NOTICE OF COMPLETION OF FINAL SUPPLEMENTAL ENVIRONMENTAL IMPACT STATEMENT (FSEIS)

Name of Action: Park Place at Westchester County Airport

Description of Action: 11 New King Street, LLC (the "applicant") proposes to construct a multi-level automated parking structure (the "proposed project") at 11 New King Street (the "project site") in the Town of North Castle, Westchester County to provide parking for users of the Westchester County Airport where there is an existing shortage of parking.

LANDSCAPE PLAN

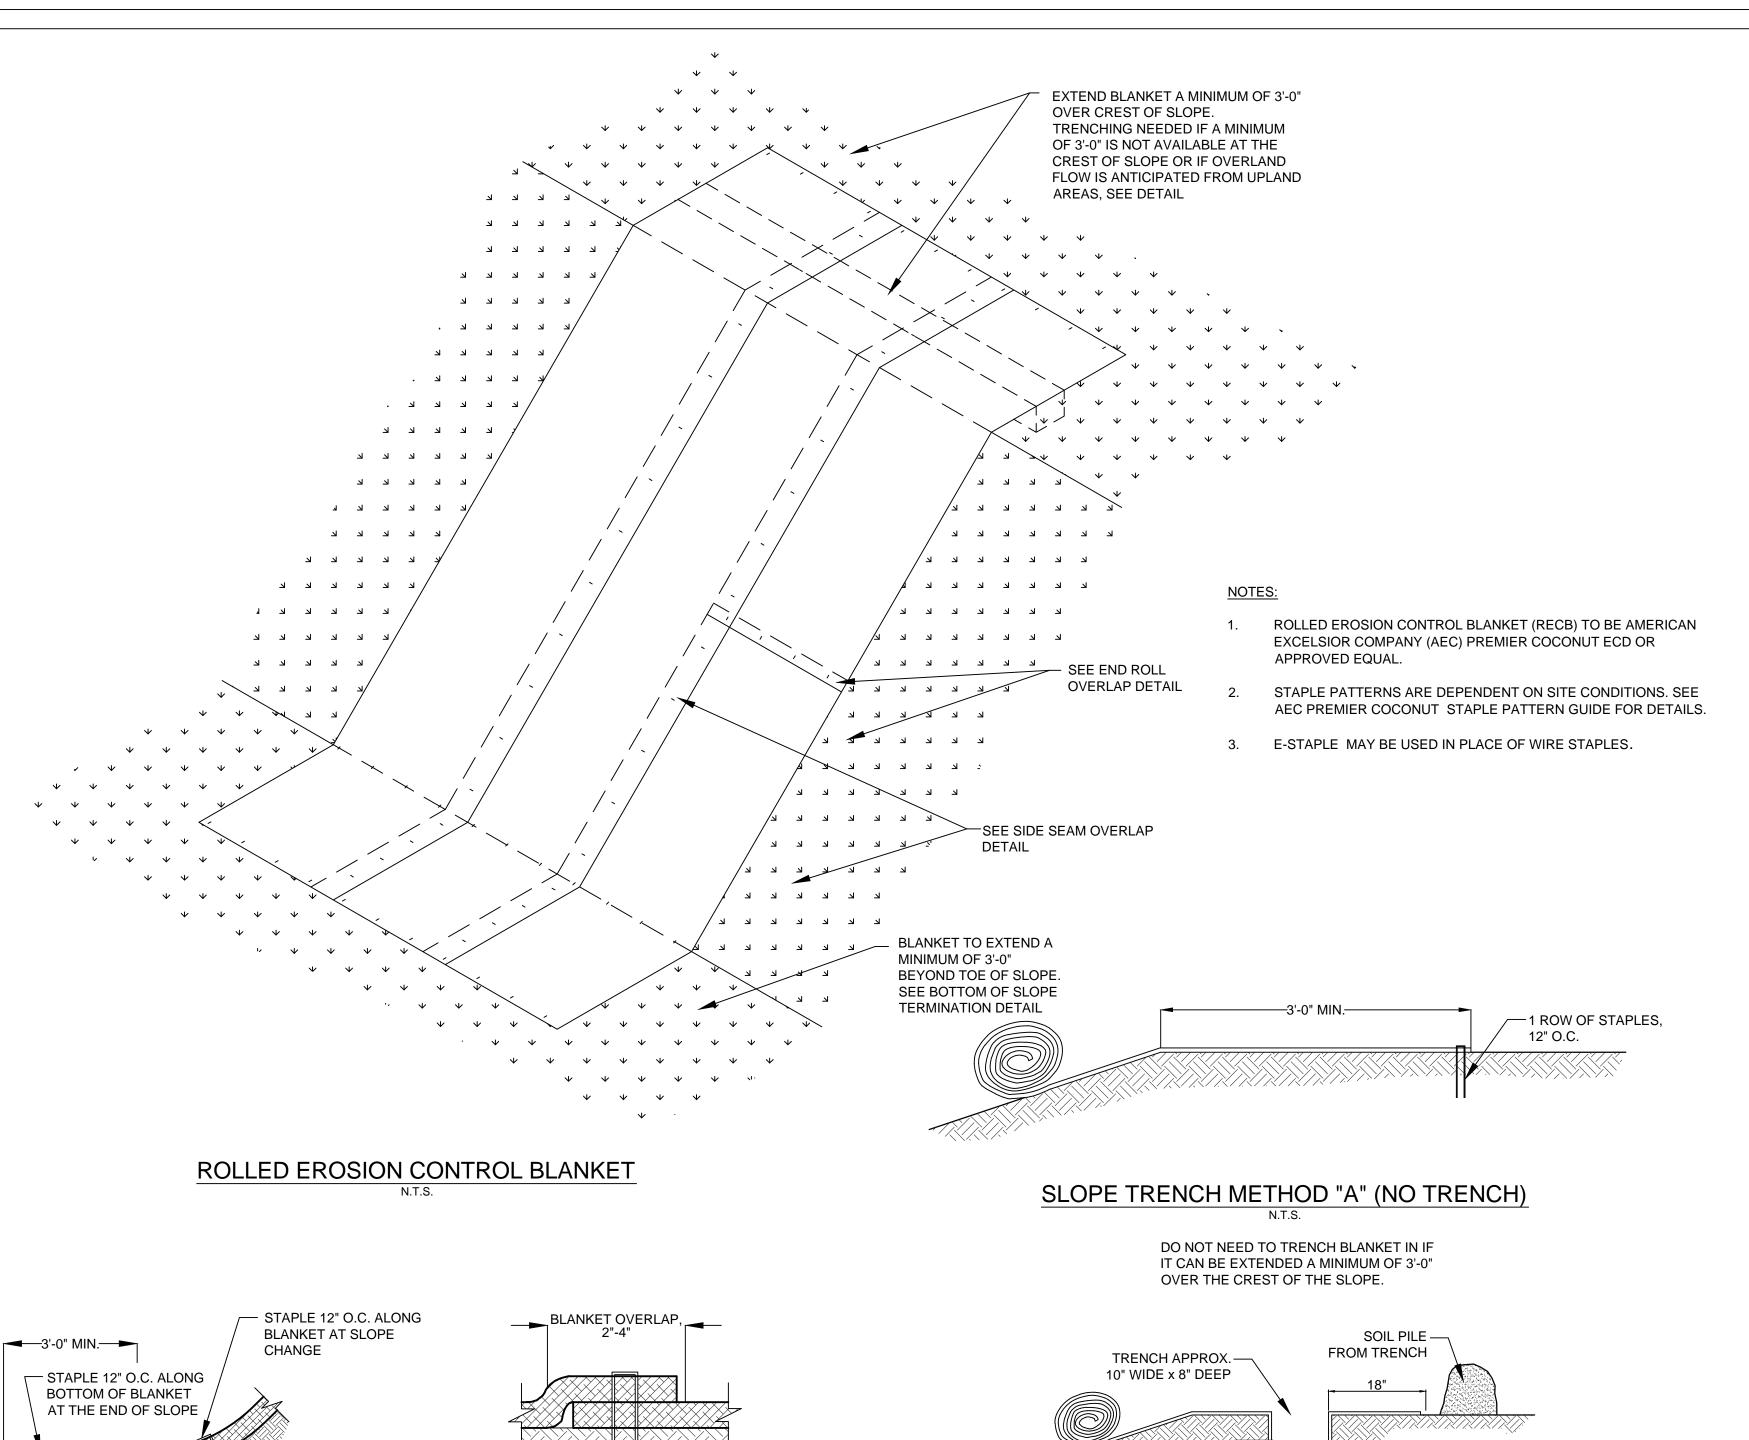
Comment 69: Landscape Plan on drawing C-9: Although quantities of area appear to have been calculated for purposes of wetland and wetland buffer mitigation, it does not appear that this has translated into plant quantities for restoring those and other areas. The plans do not indicate whether there will be sufficient quantities of plants to capture each proposed planting area with vegetation as quantities of plants and seed mixes for each planting zone and the areas that are meant for cover was not provided for review. (Garcia_NYCDEP)

- "The sponsors' proposal for placement of plants species is not addressed, and there is no specific planting plan provided concerning the wetland and wetland buffer enhancement areas, which has been deferred for consideration at the site plan approval stage." A planting plan indicating the species and size of proposed plantings has been included as part of the Site Plans. Refer to sheet C-9 Landscape Plan.

In addition, the Applicant has developed a separate "Wetland and Wetland Buffer Enhancement Plan" that proposes to remove invasive species and replant native species *outside of* (beyond the bounds of) the project's limit-of-disturbance area. Roughly 50% of this area contains non-native species and in the applicant's opinion would benefit from invasive species removal and supplemental planting with more ecologically beneficial native species. As shown in **Table 1** below and on Landscape Plan Sheet C-9, approximately 19,500 sf of wetland/buffer enhancement planting is proposed.
